WYOMING DEPARTMENT OF ENVIRONMENTAL QUALITY  
WATER QUALITY DIVISION  
PERMIT TO CONSTRUCT

PERMIT NO. 08-805

City of Sundance, Orr Subdivision – Temporary Pressure Sustaining Pump

REVIEW OF PLANS AND SPECIFICATIONS  
WYOMING DEPARTMENT OF ENVIRONMENTAL QUALITY  
WATER QUALITY DIVISION

# EXAMPLE SITE PLAN (with slopes)

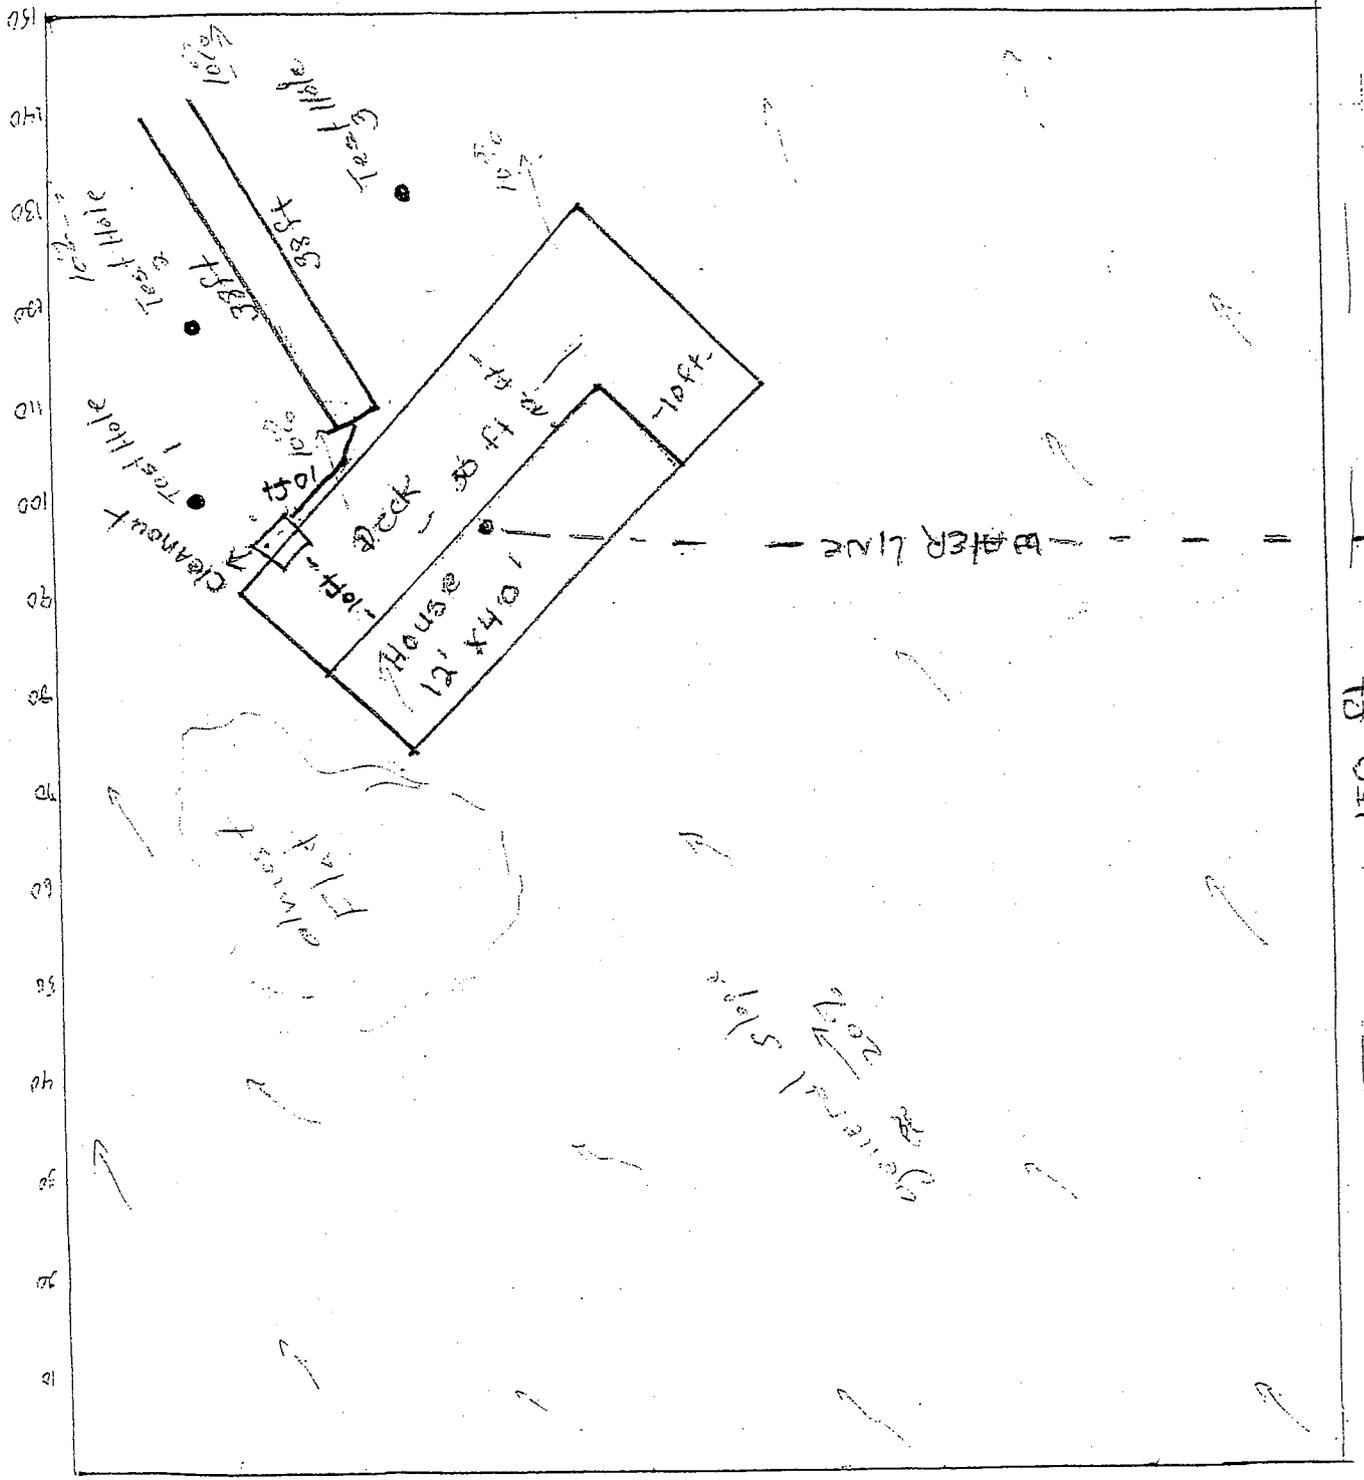
2. Site Slope - the application package indicates that the slope on this lot is 20%. The downhill direction of this slope over the property needs to be indicated on the site plan by placing small arrows ( → ) pointing downhill spread out over the lot. If there are flat areas or areas with less than 20% slope, this needs to be indicated also. An example of how to do this is included with this review.

- 1) Need to know the direction of the slope  
↳ especially in the area of the leachfield.
- 2) Also, approximate distance and direction that the shoreline is from the property is helpful.

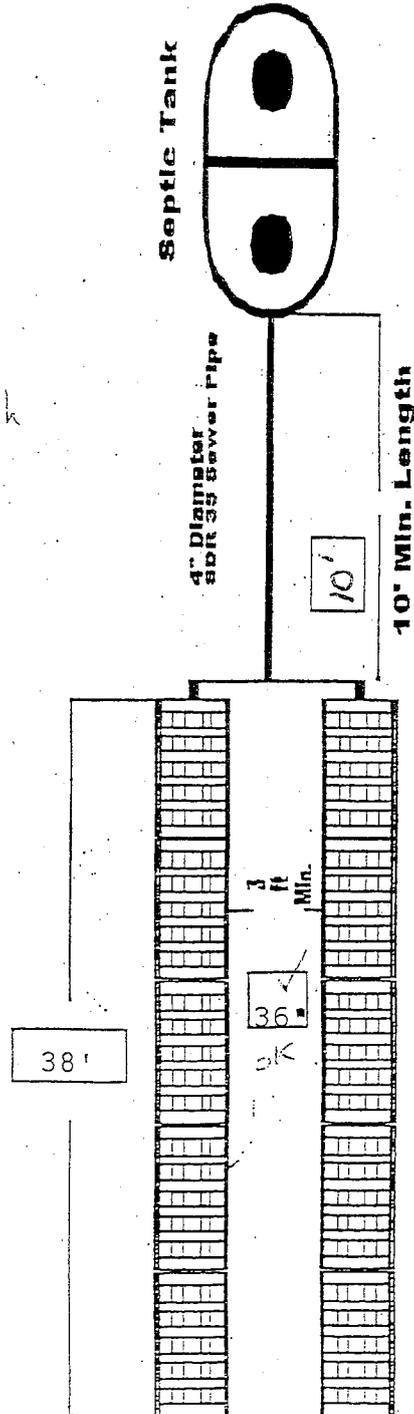
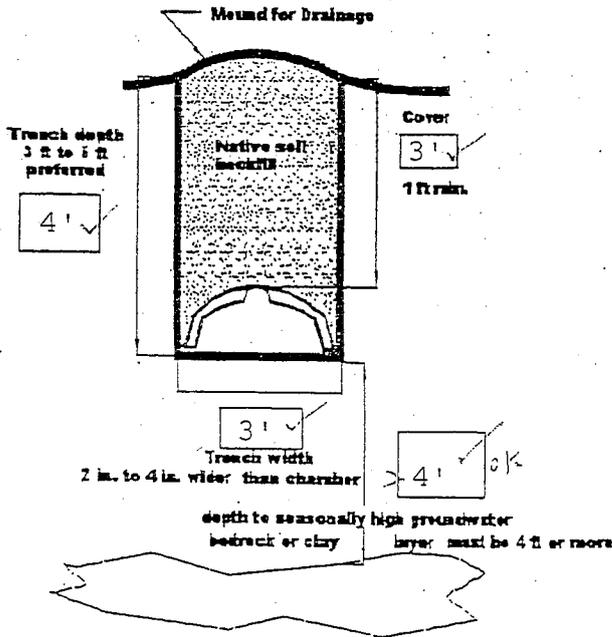
1. Verify Model of Infiltrator™ Chamber to be Used - there is confusion in the application package as to what model of Infiltrator chamber may be planned to be installed. On "Page 5" of the worksheets the dimensions of the unit are identified as, Width = 22", Height = 12", and length = 4'5". These are the exact dimensions of

the Quick4-EQ36 model, which has an equivalent area of only 18.5 square feet(sf), and not 26.5sf which was used in the calculations and is the value for the Quick4-Standard model. However, on the "Two Trench Chambered Leachfield" detail sheet the dimensions of the unit are listed as, Width = 34", Height = 12", and Length = 53", which are the correct dimensions for the Quick4-Standard model chamber unit.

Therefore, when responding to this review, you must verify and confirm which of these two units you will actually be using. If it is then the two trenches will have to be extend if there is room to extend them another 12 feet without getting to close to the property lines. If this occurs a different trench layout will have to be used.

# SITE PLAN No Good

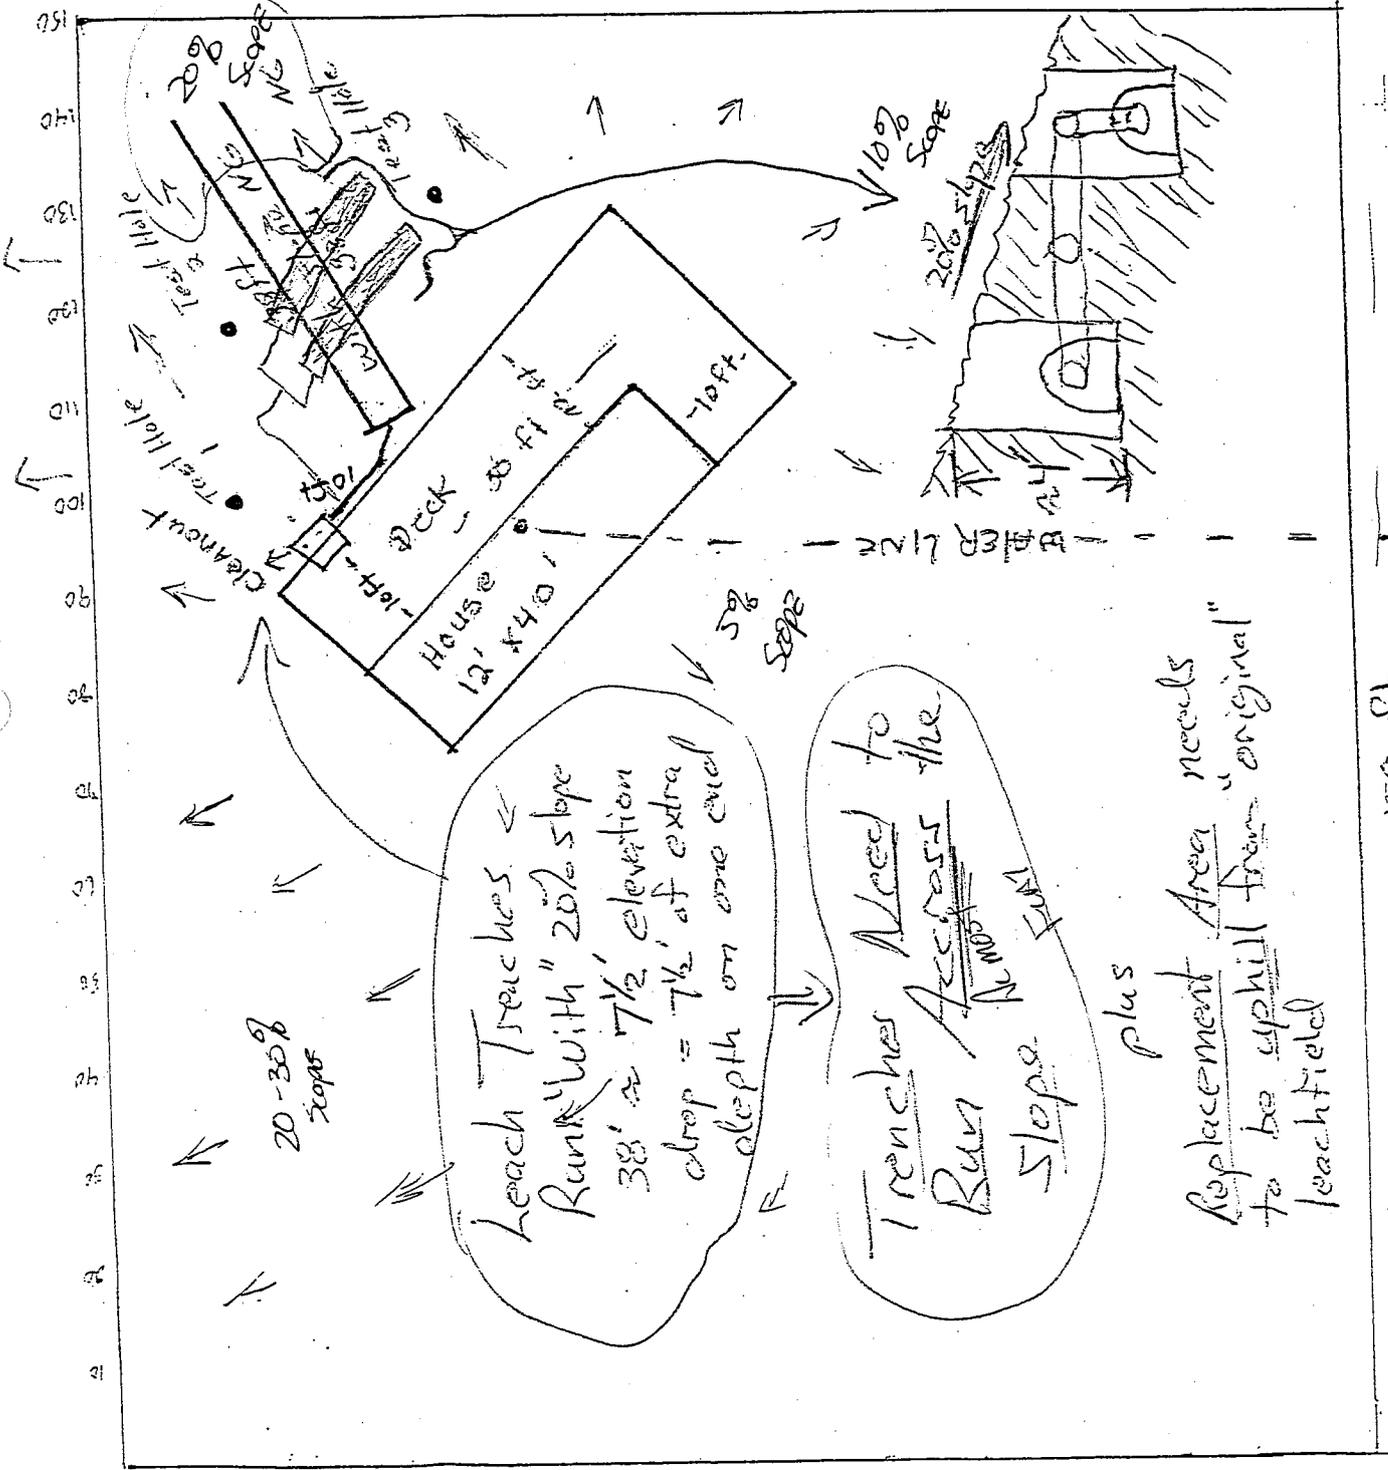
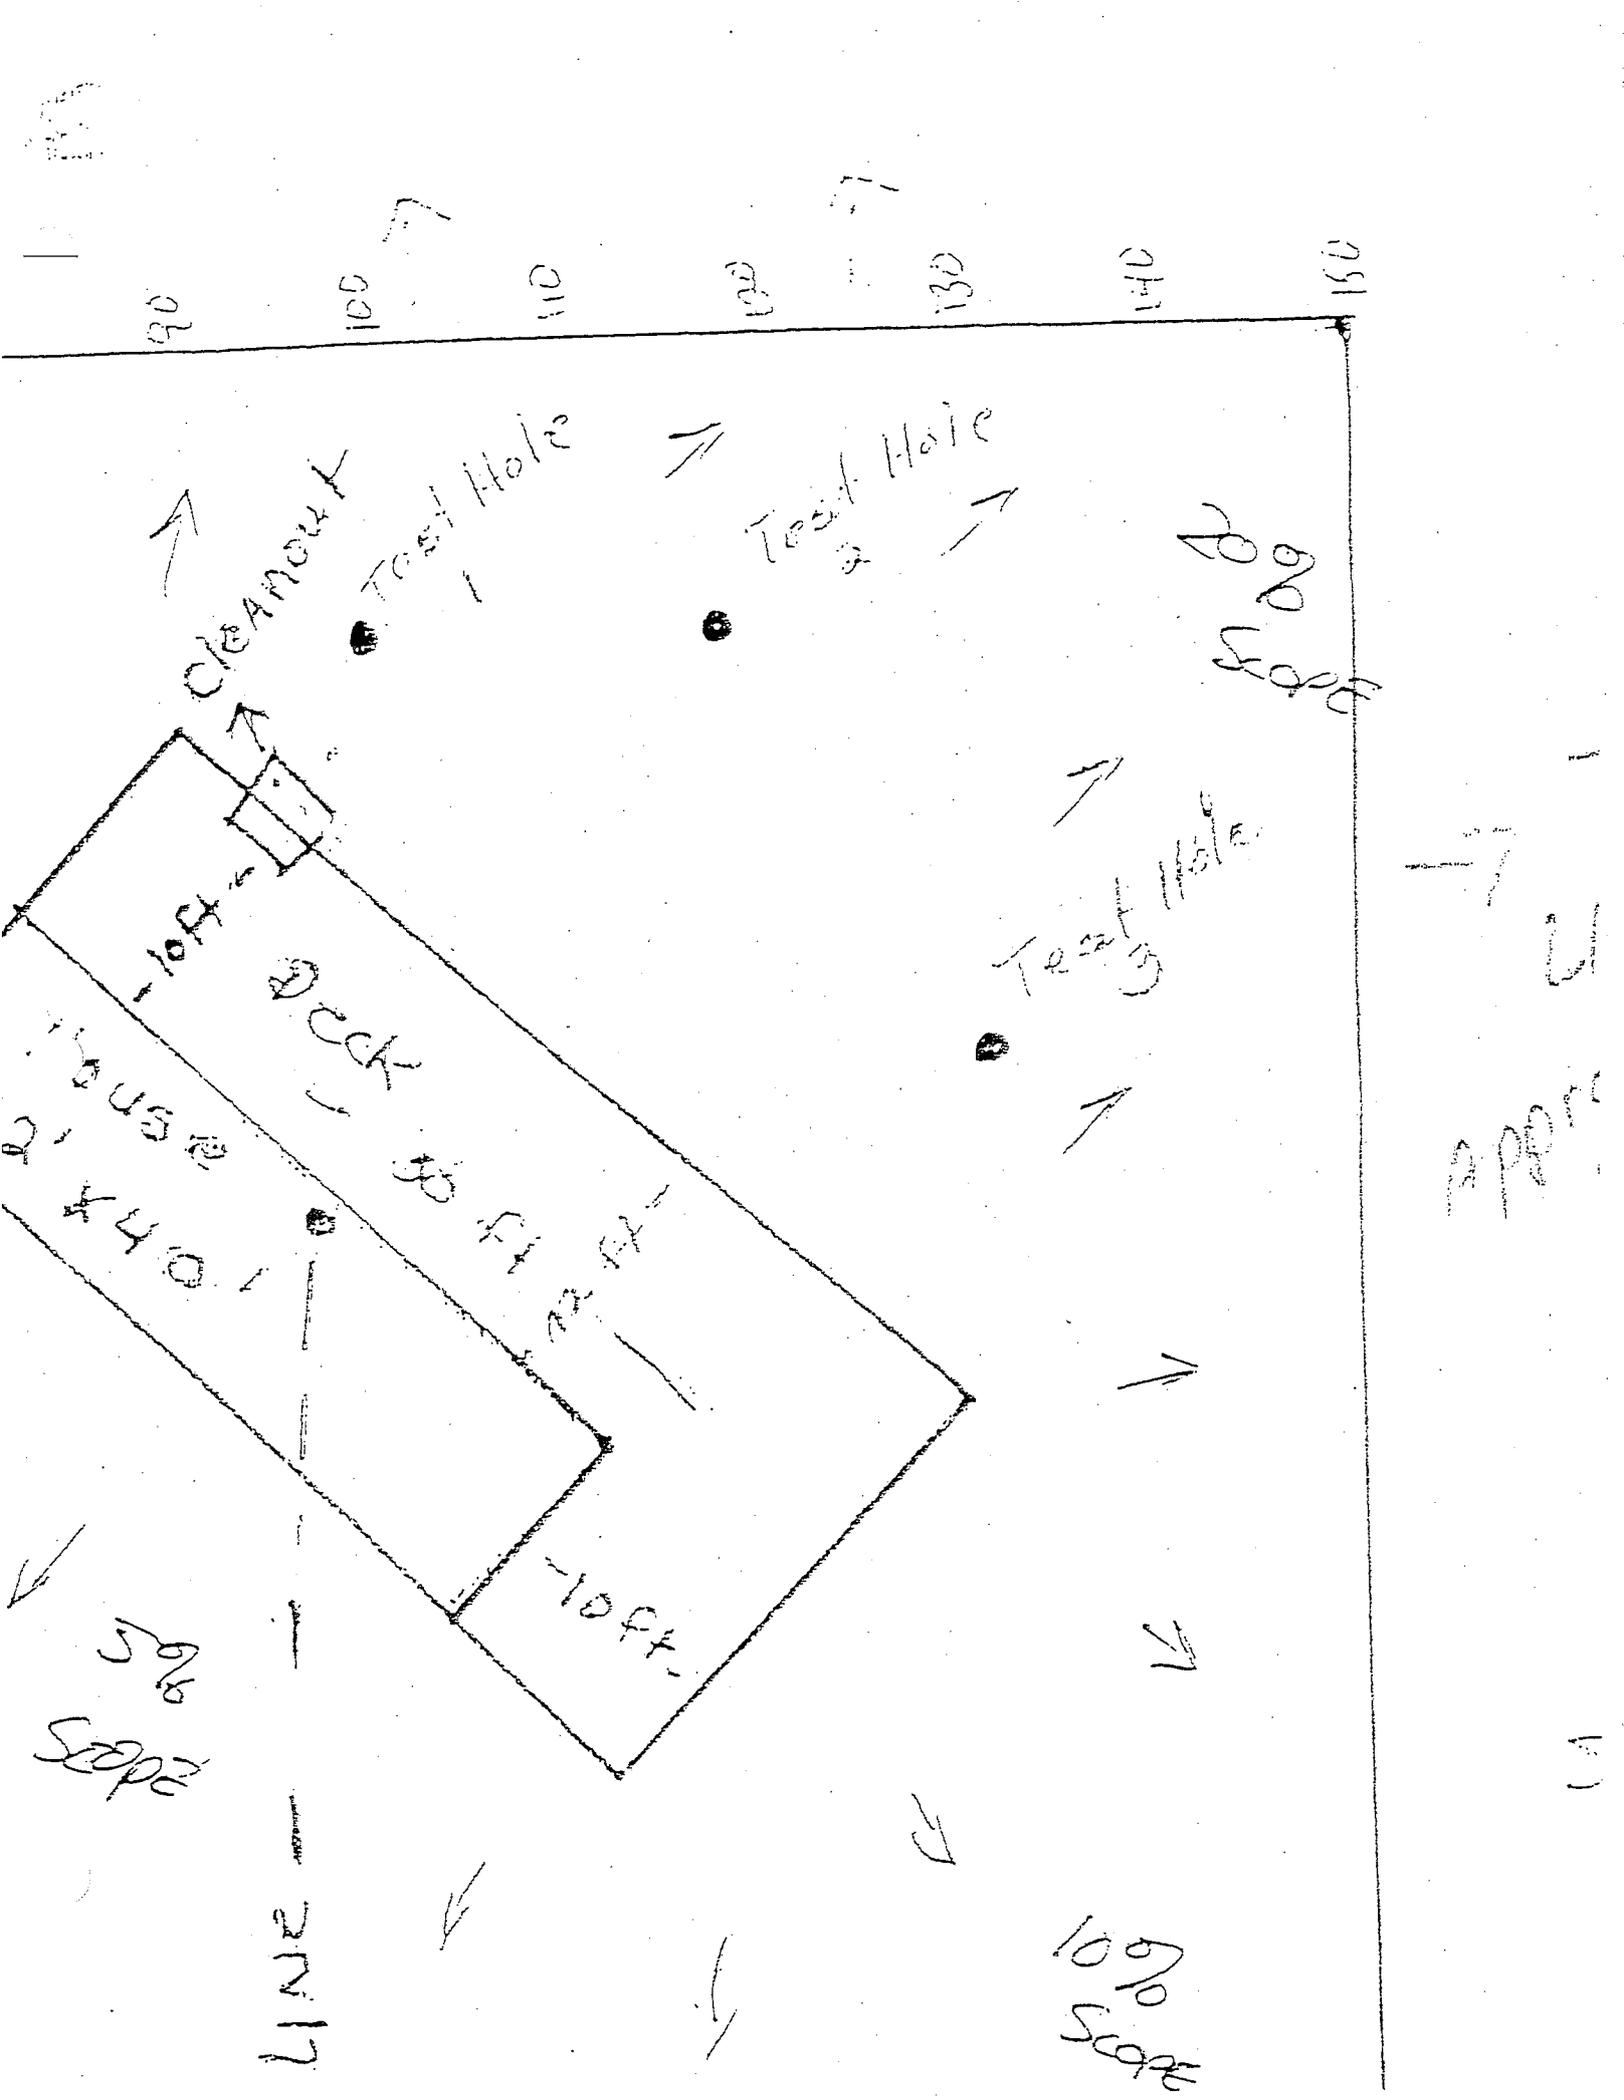
1. Leachfield Site Surface Slopes and Leachfield Trench Depths - the response to the first review comments indicates that the surface slope in the area where it is planned to locate the leachfield trenches is about 20% downhill running in the same direction as the trenches. This will not work because at 20% slope over a length of

Please redo the location and orientation of the leachfield trenches to address these concerns and resubmit the revised site plan.
